PLANNING BOARD MEETING AGENDA

May 22, 2025 at 7:30 PM

432 Route 306, Wesley Hills, NY 10952

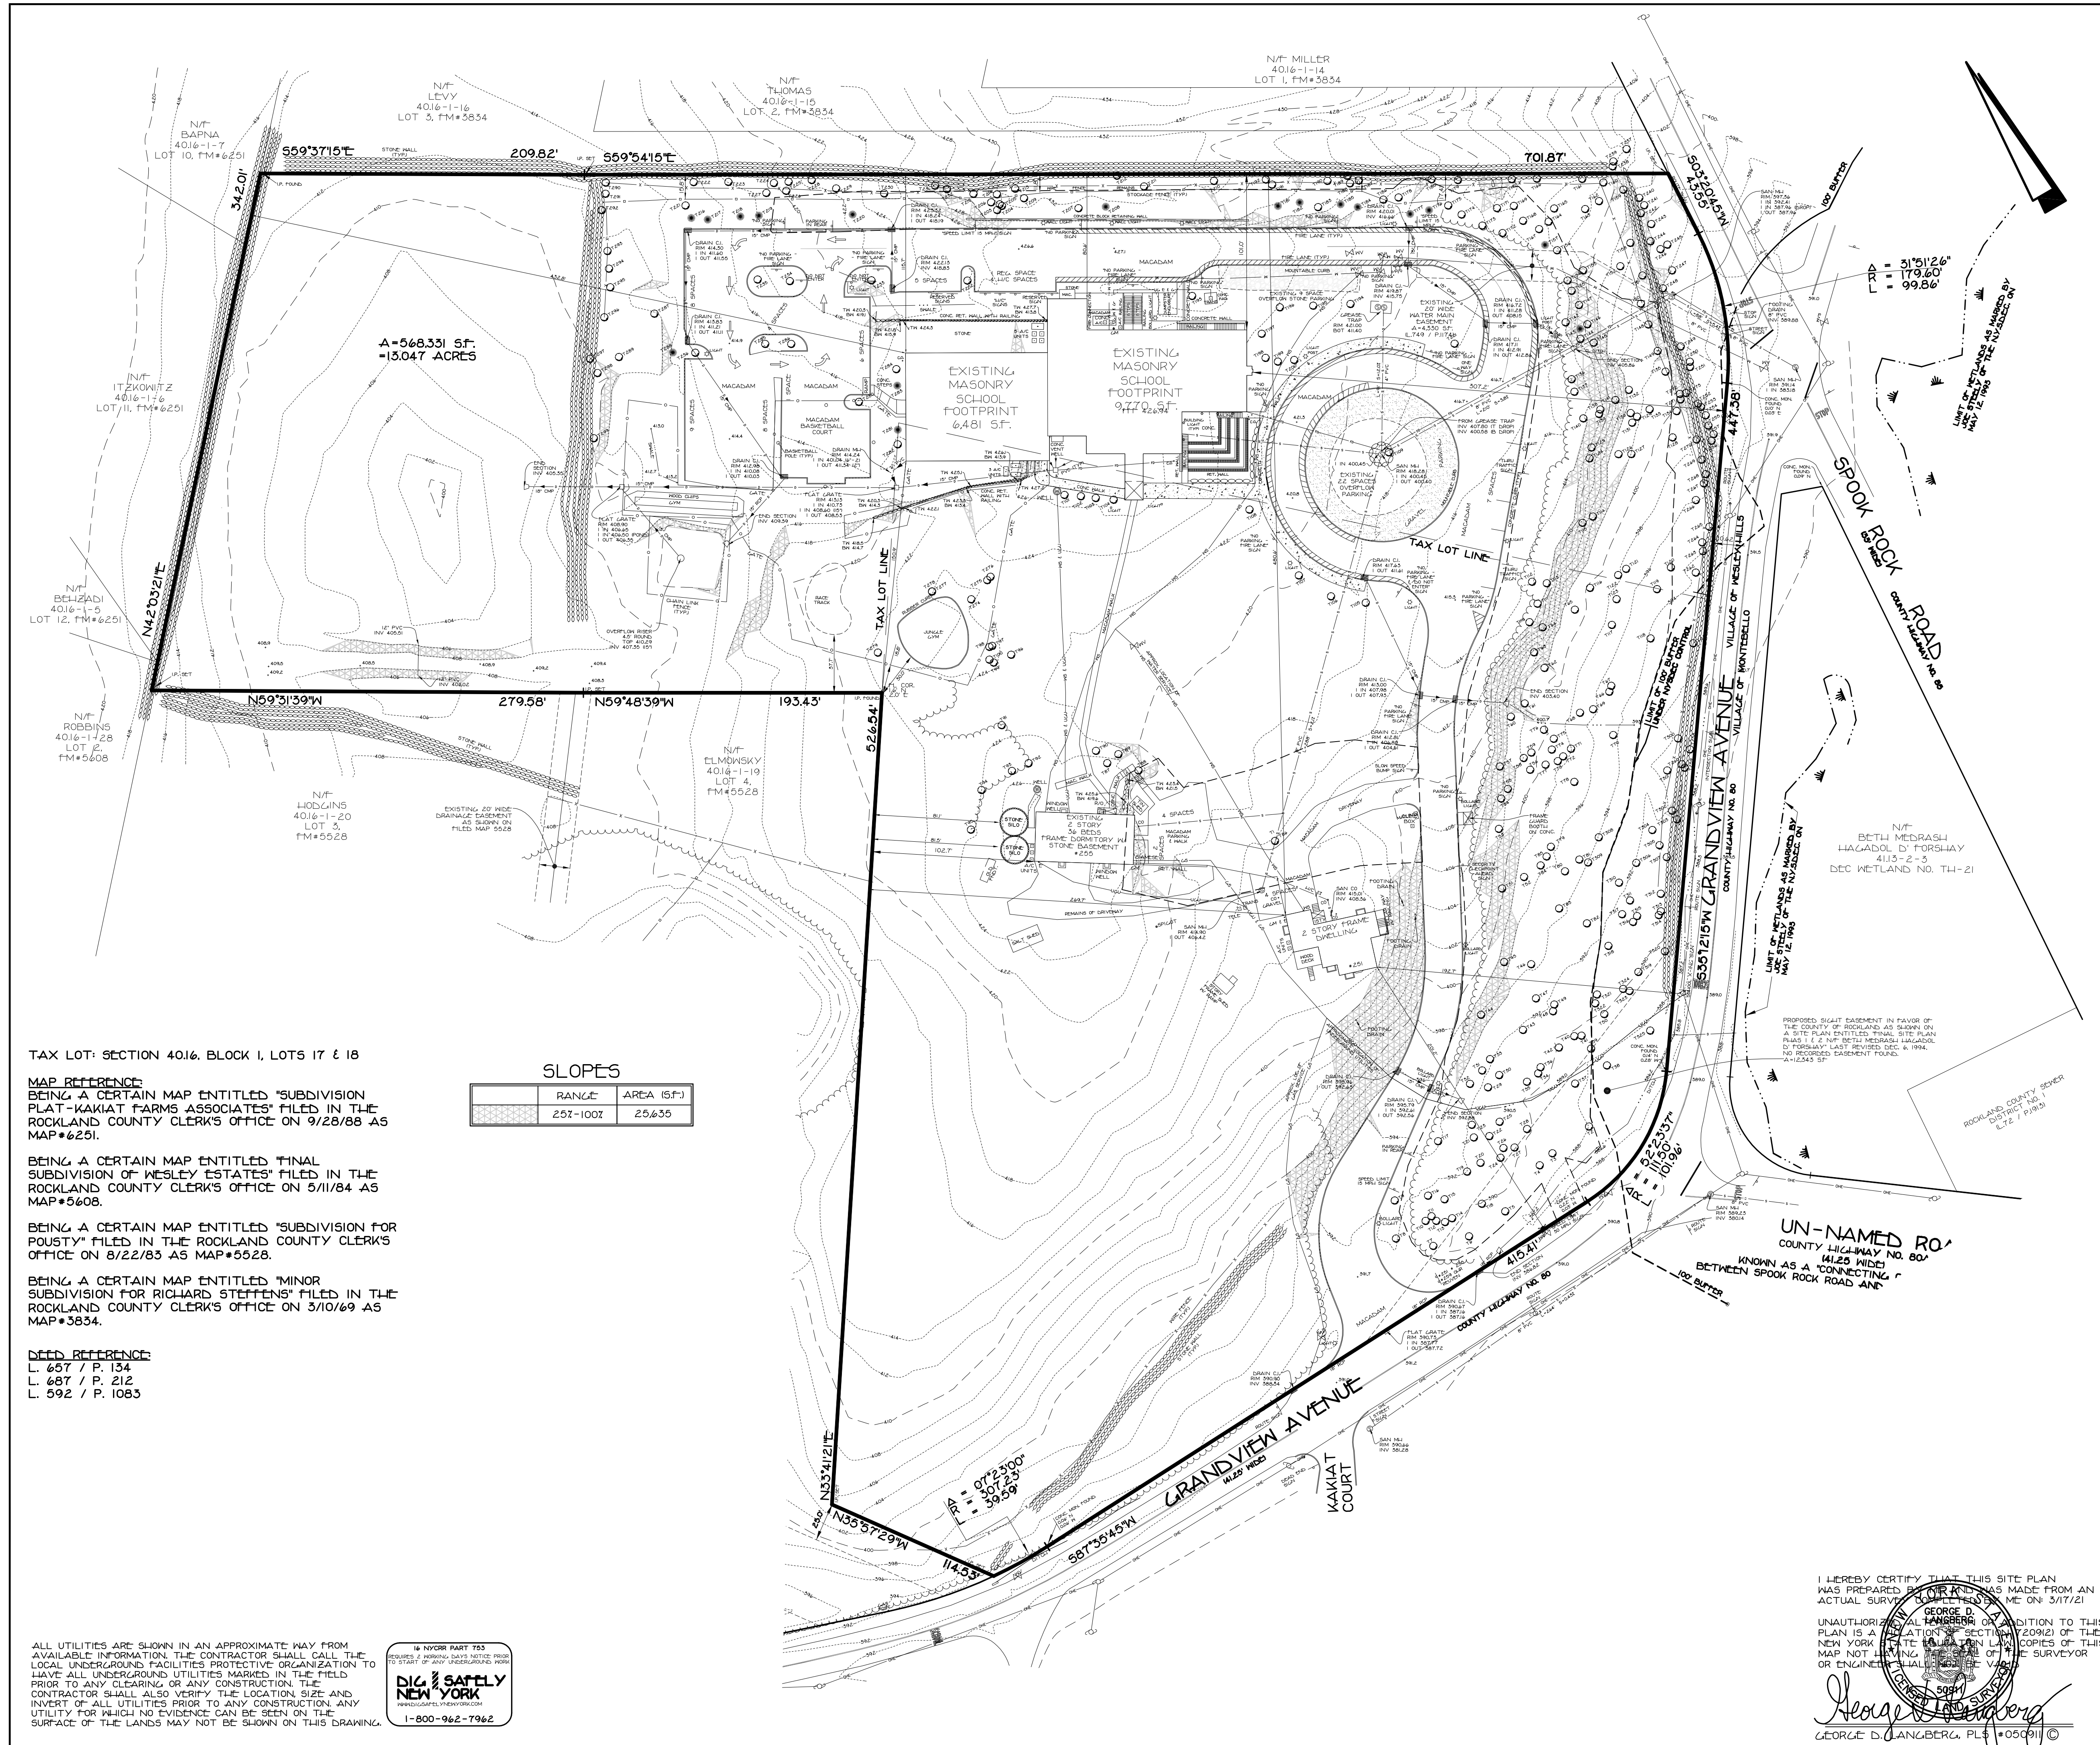
1. The Part Plans provided on sheets 2, 3 and 4 of the site plans are extremely difficult to read. The use of part plans for this project is acceptable. But the plans provided essentially combine the Layout Plan, Grading Plan, Utility Plan, Erosion Control Plan and Lighting Plan into a single view. As a result, some of the text is so small as to render it illegible. The site plans must be revised to more clearly present the required information.
